COMMUNITY MASTER PLAN

LEVEL B PLAN: AS APPROVED BY DEVELOPMENT REVIEW BOARD FEBRUARY 2008

AMENDED FEBRUARY 2024

Mesa del Sol

Figure 5-6

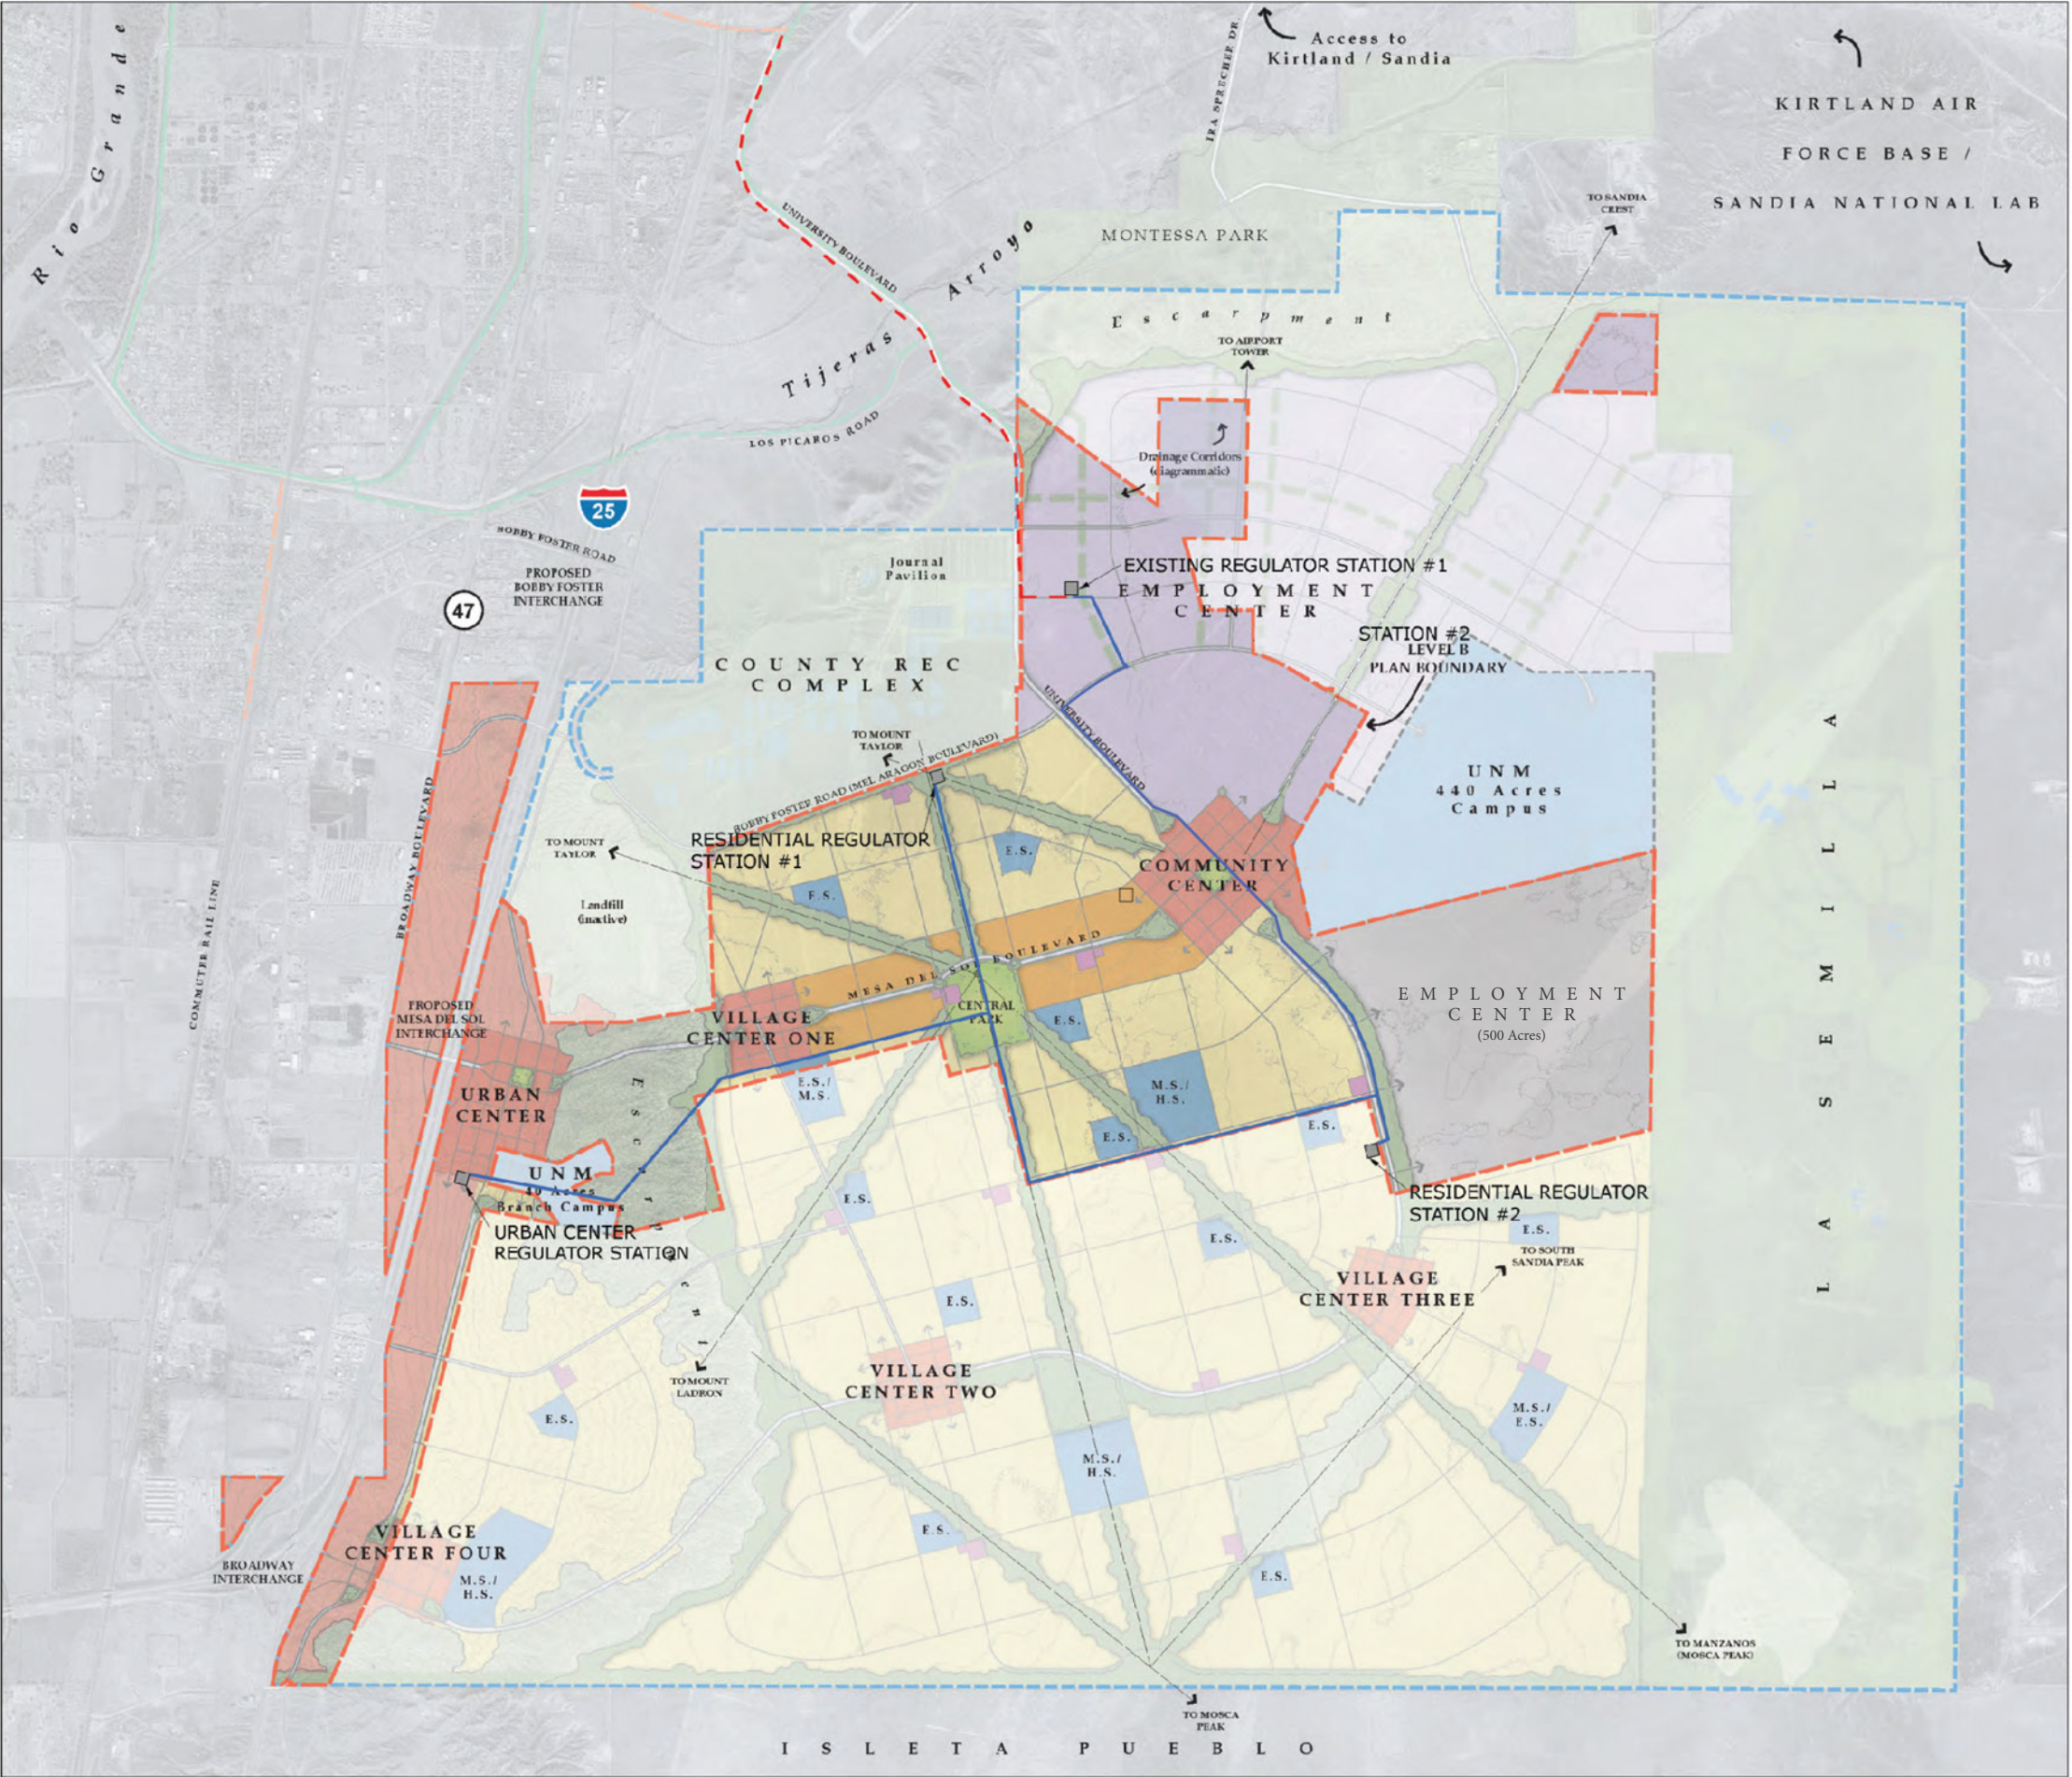
- Figure 5-5 updated Transmission Line Routing to show relocated Substation #1 and transmission line through project area.
- Figure 5-6 Update Gas Line Routing to show relocated Regulatory Station #2 and 10” VHP distribution line

Revised September 2012 - addition of Tract D and removal of Tract 8 from plan area.
Revised August 2021 - modifications to utility corridors within a southern portion of the Employment Center, as shown.
